**Greater Geelong Planning Scheme Amendment C436ggee
and Planning Permit Application PP573- 2021
Stage 5, Balmoral Quay, Rippleside**

Panel Report

10 April 2024

Figure 11 Concept sketch from Urban Design Guidelines

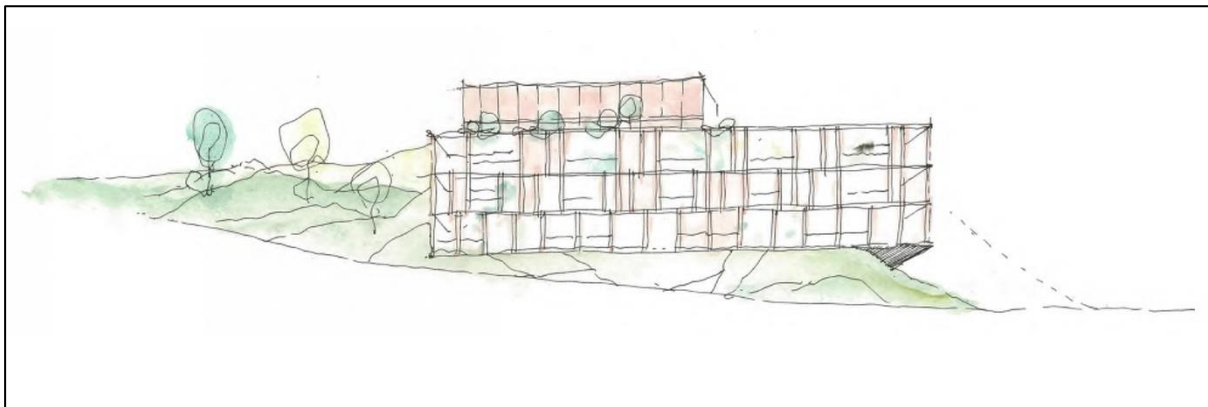
Mr Milner was critical of the exhibited Urban Design Guidelines and the proposed changes and identified various inconsistencies. One inconsistency was the new architectural image (reproduced in Figure 11 below) inserted into the guidelines. He said it showed a smaller building than that proposed with a different number of levels and set into a different surrounding context.

In terms of Mr Milner's criticism of the image reproduced in Figure 11 above, the Panel agrees this is inconsistent and misleading with what is proposed and should be deleted from the Urban Design Guidelines.

- The Urban Design Guidelines should be revised to:
 - delete the concept sketch extracted in Figure 11 of this Report
 - include any consequential amendments to images, plans, indicative diagrams, or provisions which require updating as a result of the Panel's recommendations to the proposed building envelope and built form layout.

Figure 12 Alternative design – floor plan

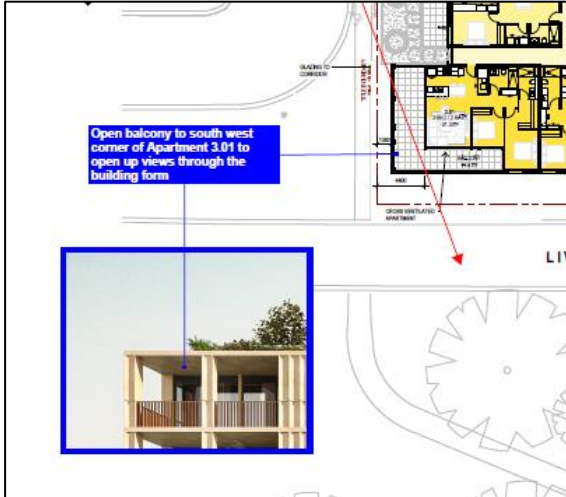
south-west corner of Apartment 301 was replaced with an open balcony to allow for views through the built form. This change constitutes a 4.4 metre setback from the western property boundary compared to the original setback of 1.38 metres. See Figure 12 and Figure 13.

Figure 14 Extract of view line diagram

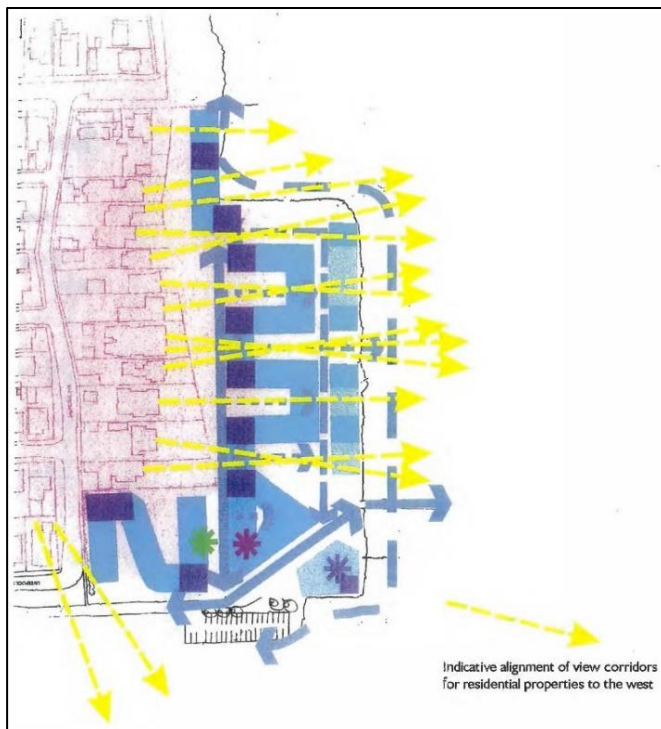
Council supported the sharing of views as proposed and referring to the view corridor diagram from the Urban Design Guidelines (see Figure 14). It submitted this diagram contemplates views will be maintained *“around”* the subject land, and that there was no anticipation of views being provided *“over”* the subject land.

The Proponent also referenced the view corridor diagram (Figure 14) from the Urban Design Guidelines and submitted:

In terms of the inconsistencies within the Urban Design Guidelines, the Panel considers the view line diagrams extracted in Figure 15 should be deleted for the reasons discussed above. The view line diagram in Figure 14 sits within Section F7 Implications: Buildings which appears to be the wrong section for such a diagram. This should be moved to Section G2 Interface Issues: Views in pace of the view line diagram to be deleted.

Figure 15 Extract of view line diagram

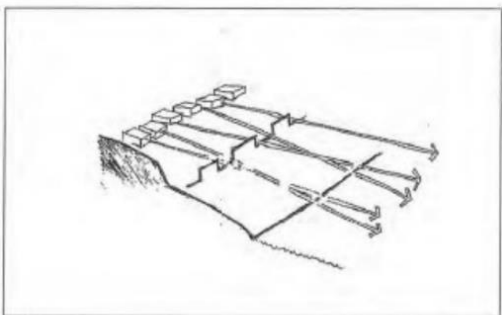
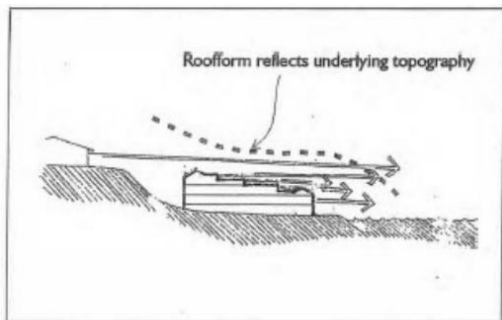
For example, Figure 15 referenced above shows two arguably contradictory diagrams - one diagram shows views over rooftops and the other shows views between buildings. Both diagrams then differ from Figure 14 which shows the location of specific view lines. Equally, references in the Urban Design Guidelines such as “*allowing views of the majority of Corio Bay from the eastern*

Figure 17 Ms Marshall’s revised Balmoral Crescent access arrangement

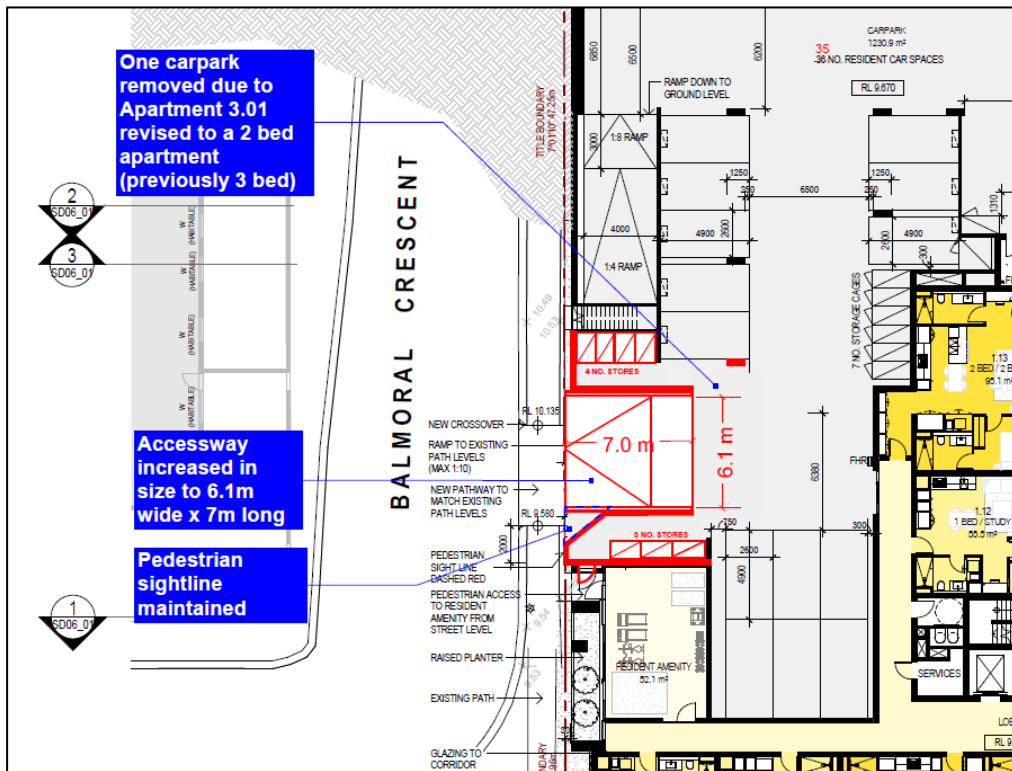
- provided a revised Balmoral Crescent driveway arrangement with the security gate setback seven metres³⁰. This was subsequently endorsed by the traffic experts and supported by Council (refer to Figure 17)
- prepared revised permit conditions to require a RSA³¹.

Figure 19 Revised Pedestrian access Balmoral Crescent

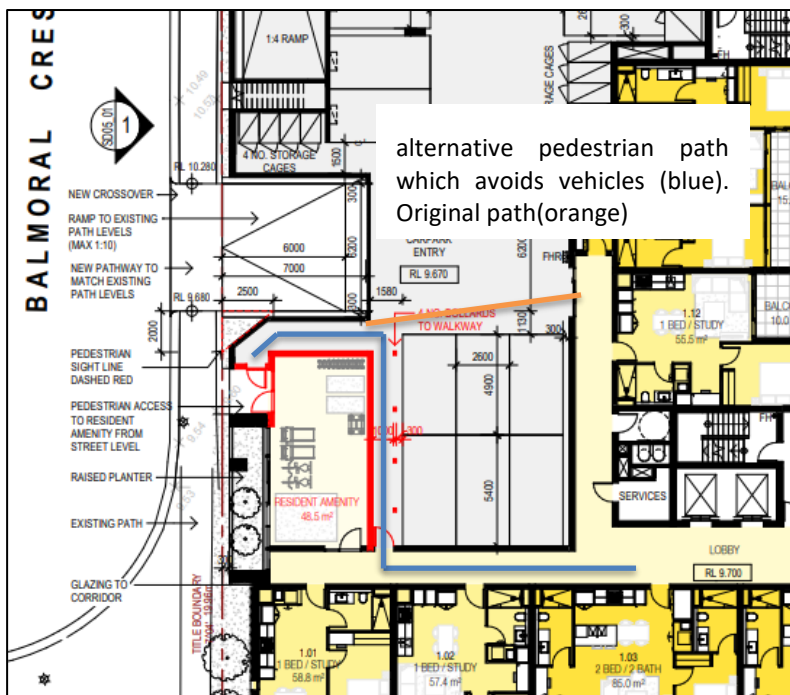
At the traffic conclave, Ms Marshall and Mr Walsh agreed the pedestrian access arrangements at the Balmoral Crescent access could be improved, such that pedestrians within the car park and also using Balmoral Crescent for access would be better facilitated by not having to cross the main entry to get to the lift core.

The Proponent prepared a concept plan (refer to Figure 19) to illustrate how this might be achieved which both traffic experts supported.

Figure 20 Lower Ground Level car park – proposed wheel stops

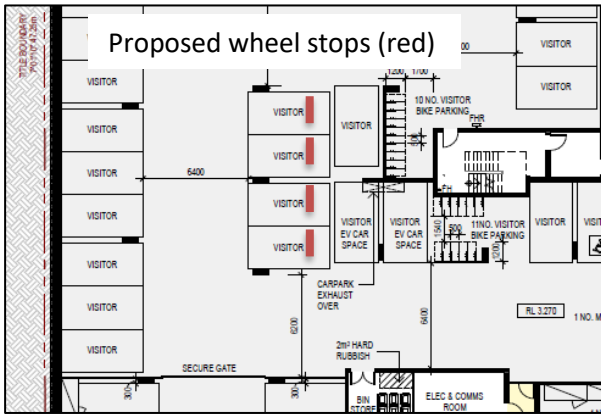
- car park:
 - four visitor car parking spaces should have wheel stops to ensure parked vehicles do not encroach into neighbouring bays or potentially striking parked cars (refer to Figure 20)

Figure 21 Balmoral Crescent/Yacht Approach proposed pram crossings to replace kerbing

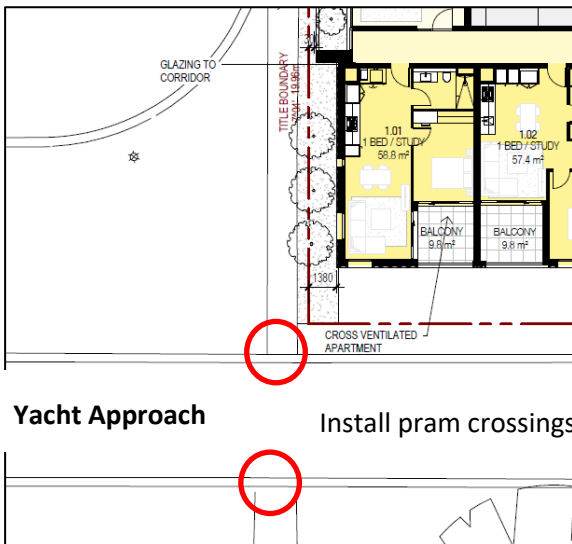
- convex mirror on the approaches to the single lane two-way ramp between ground level and level 1 car parks. This would enable approaching motorists to see if a vehicle is on the ramp and to prop allowing the motorist on the ramp to exit. This would avoid a situation where both opposing vehicles are on the ramp, necessitating one motorist having to reverse back along the ramp
- footpath connectivity:
 - Balmoral Crescent footpath at Yacht Approach - replace kerb upstands with pram crossings to improve access for mobility impaired and pedestrians with prams and strollers (refer to Figure 21)

Yacht Approach Install pram crossings

Figure 22 Harbourside Drive – proposed pedestrian link

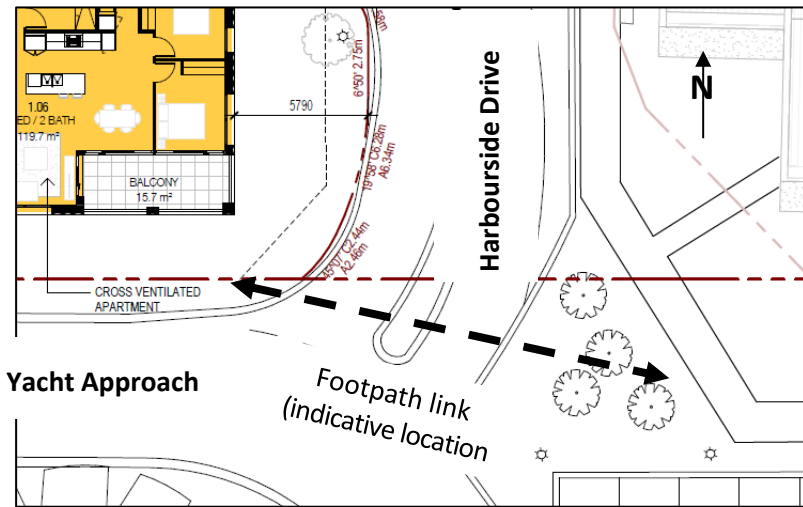
- Harbourside Drive - introduce a footpath link across Harbourside Drive to connect into the existing footpath on the east side of the roadway (refer to Figure 22).
